PUBLIC HEARING MEMORANDUM

SUBJECT: **Petition #215-18**, for SPECIAL PERMIT/SITE PLAN APPROVAL to allow a rear lot subdivision to create two lots, raze the existing single-family dwelling and construct single-family dwellings on each lot at 156 Otis Street, Ward 2, West Newton, on land known as Section 24, Block 13, Lot 14A, containing approximately 43,700 sq. ft. of land in a district zoned SINGLE RESIDENCE 2. Ref: 7.3, 7.4, 3.1.5, 3.1.10 and 5.4.2.B of Chapter 30 of the City of Newton Rev Zoning Ord, 2015.

ZONING REVIEW MEMORANDUM

MEMORANDUM

Drain Atlas & GIS Map shows City Drain Easements

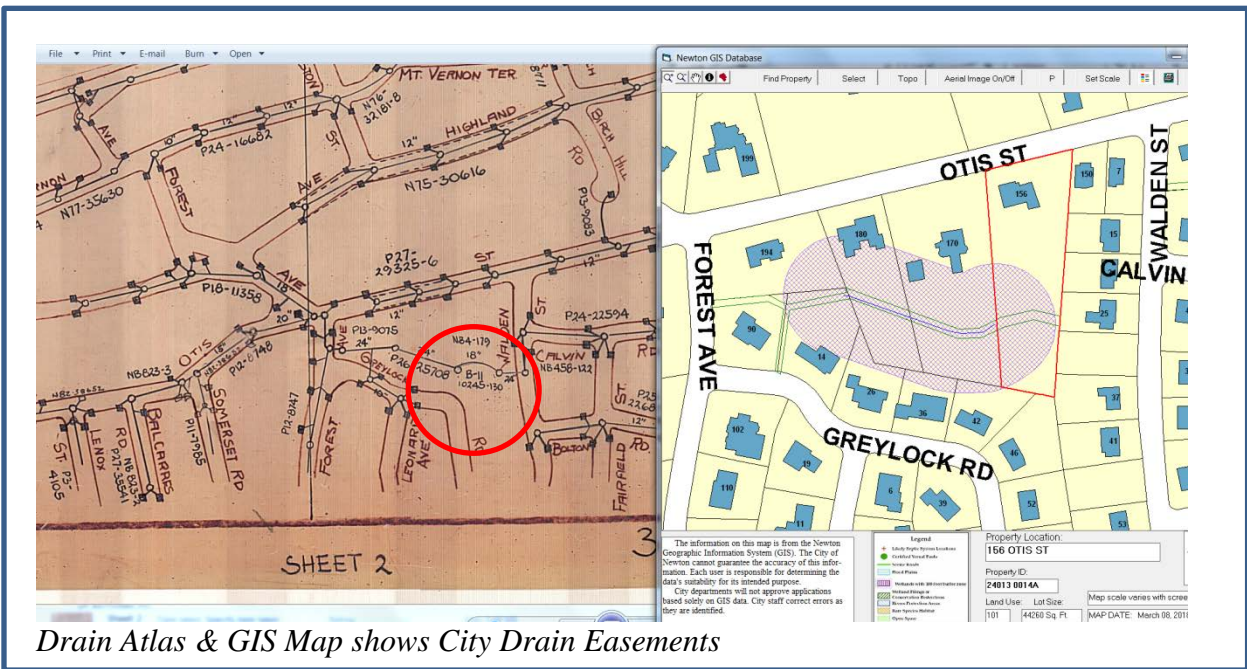
The site is just over 1-acre; it is heavily wooded with mature trees, dense ground cover, and vines. The property is bound on the north by Otis Street, and on the west, south and east by residential homes. Towards the rear portion of the lot a 15-foot wide City Drain Easement traverses the site; according to the following plans drain pipes were installed to channel the brook. A stream was flowing on the surface during a site visit yesterday. The stream elevation drops approximately 18-feet from west to east. It is important to note that no heavy equipment will be allowed to cross the drainage easement.

The site has a high point of 138' near the western property line then slopes towards the eastern property line at elevation 118-feet. Near the southern property line a high point of 136' slopes fairly steeply down towards the drain easement. Ultimately the entire site drains from the west towards the east.

The engineer has designed a stormwater system to store the 100 year storm event from all impervious surfaces and calculations have been submitted to the Conservation Commission which proves that the systems will drain within the required 72 hours mandated by the DEP by having an overflow connection to the drainage system in Otis Street.

In light of this, the engineer needs to perform a *pre & post Closed Circuit Television (CCTV)* inspection of the drain pipe in Otis Street and submit capacity calculations to verify that there is no impact to the City system downstream. Otis Street was paved in 2015, a five [5] year moratorium on the street is in place until 2020; any trench work within the street will require curb line to curb line cold planning and overlay for the entire frontage of the property. Additionally cement concrete sidewalk and granite curbing will be required.
